Access Compliance Report

Public Rights-of-Way

(Curb Ramps)

Intersection ID: 53413	Main Street: GOLF_LINKS_DR	Cross Street: WAVERLY_WALK_AV	Location: NE
ADA ID: 76E1A41DE577	Ramp Type: Perp	Initial Pass/Fail: Fail	Overall Compliance: No
		Severity Score: 12.5

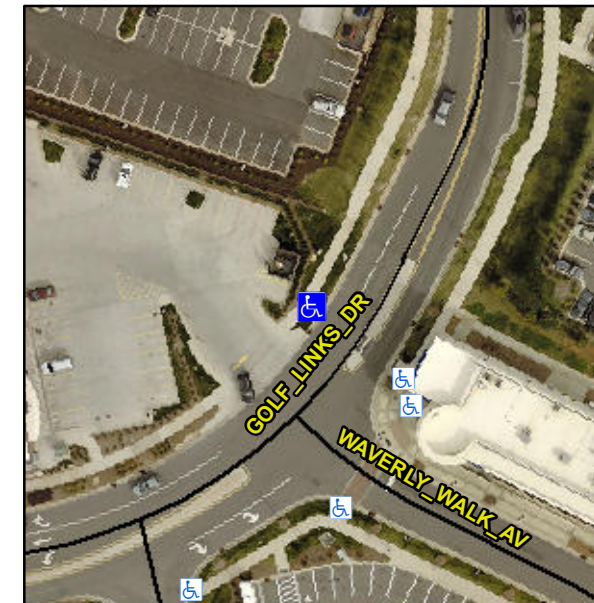
Not Found, R304.2.2

Compliance	Description	Data	Compliance	Description	Data
N/A	Ramp Length (in)	72.0	No	Ramp Slope (%)	9.3
Yes	Ramp Width (in)	71.0	Yes	Ramp XSlope (%)	0.5
N/A	Flare Type LT	N/A	N/A	Flare Type RT	N/A
N/A	Flare Slope LT (%)	N/A	N/A	Flare Slope RT (%)	N/A
N/A	Flare Traversable LT?	N/A	N/A	Flare Traversable RT?	N/A
N/A	Landing Length (in)	N/A	N/A	DWS Provided?	N/A
N/A	Landing Width (in)	N/A	N/A	DWS Contrast?	N/A
N/A	Landing Slope (%)	N/A	N/A	DWS Length (in)	N/A
N/A	Landing X Slope (%)	N/A	N/A	DWS Full Width?	N/A
N/A	Landing Curb? (Y/N)	N/A	N/A	DWS Offset (in)	N/A
N/A	Shared Landing?	N/A			
N/A	Gutter Ponding?	N/A	N/A	Gutter Slope (%)	N/A
N/A	Gutter Lip Ht (in)	N/A	N/A	Gutter X Slope (%)	N/A
N/A	Painted X Walk1?	No	N/A	Painted X Walk2?	N/A
	X Walk 1 Direction	To SE		X Walk 2 Direction	N/A
N/A	X Walk 1 Width (in)	N/A	N/A	X Walk 2 Width (in)	N/A
	X Walk 1 Slope (%)	2.4		X Walk 2 Slope (%)	N/A
	X Walk 1 X Slope (%)	1.2		X Walk 2 X Slope (%)	N/A

Remove & Replace Entire Ramp.
